RE: Rochester Housing Authority,  
**Parking Lot Improvements-Elmdorf Apts.**

**ADDENDUM #1**

re Rochester Housing Authority  
Parking Lot Improvements - Elmdorf Apartments

This Addendum consists of three (3) pages including attachments, and forms part of the Contract Documents, and modifies the original Bidding Documents dated 01/10/2014 as noted below.

DRAWING TITLE:  
**SITE PLAN**  
1 of 3  
SHEET No: **C1.0A**  
JOB No: 0509-13  
DRAWING No:

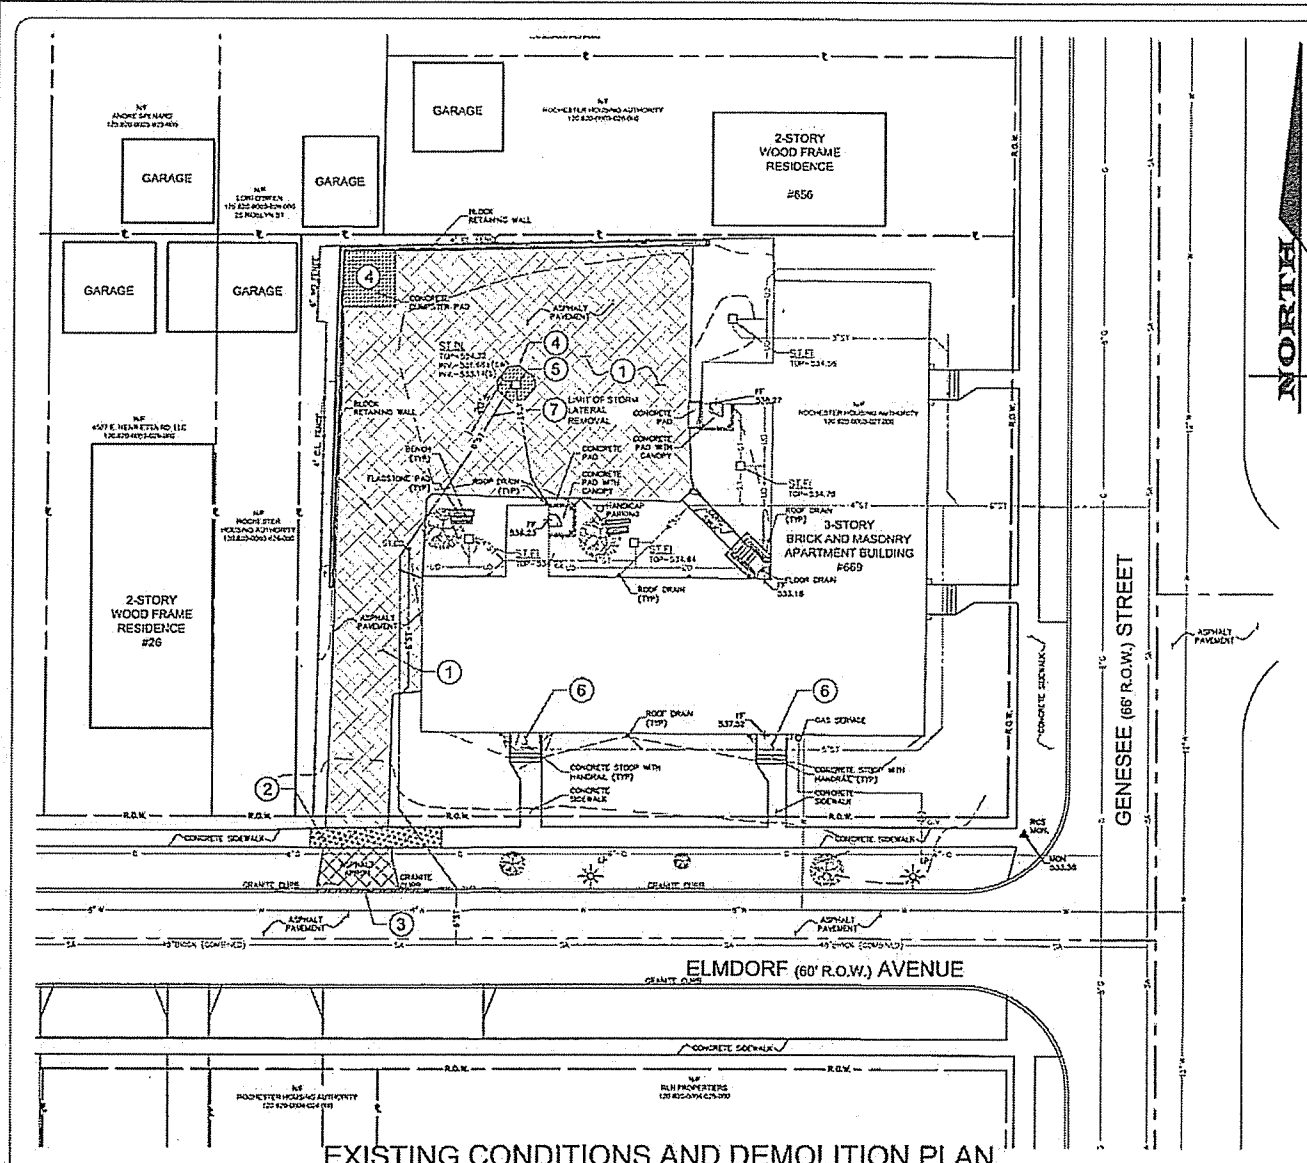
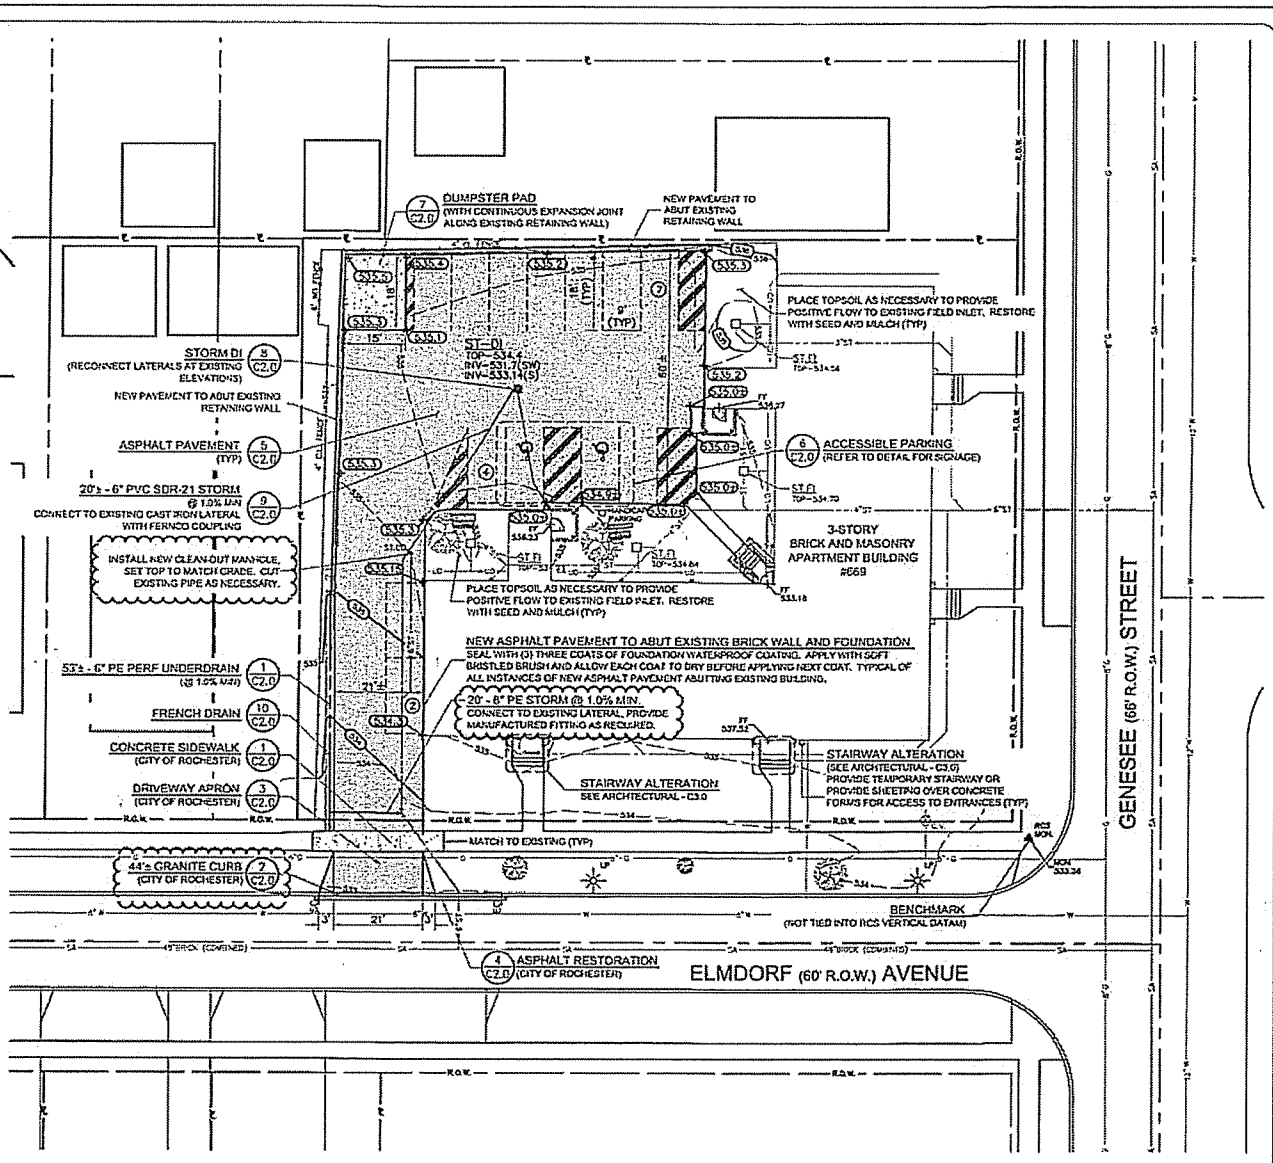
- 3 Add Addendum Drawing C1.0a;
    - a Update existing storm cleanout note to include installing a cleanout manhole for existing storm cleanout.
    - b Added linear footage of granite curb to be installed and/or replaced.

- c Updated french drain connection note to include providing a manufactured fitting for connection.
    - d Added striping for additional Accessible Parking Spot and amended the callout.

**6 RESERVED PARKING AND SIGNAGE**

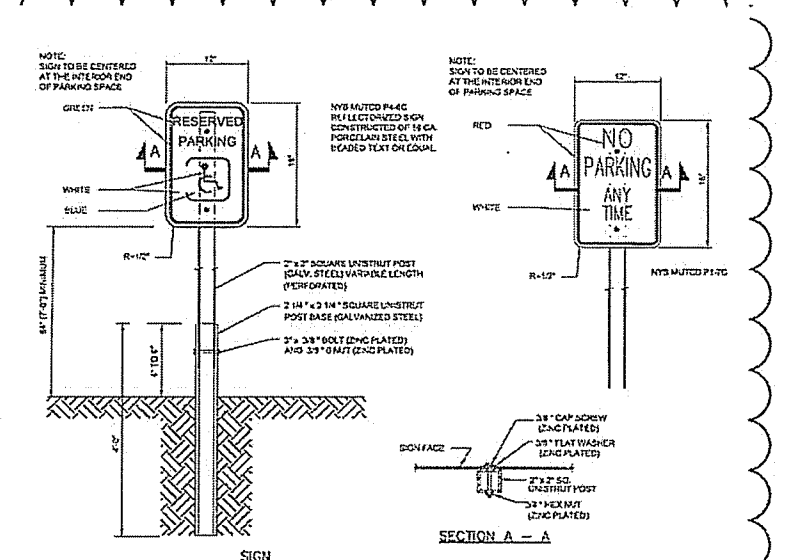
- B Add Addendum Drawing C2.0a;
- 1 Reserved parking and Signage #6 detail to show existing site conditions
  - 2 Catch basin #9 modified to show 'Type C' catch basin as required by the City of Rochester.
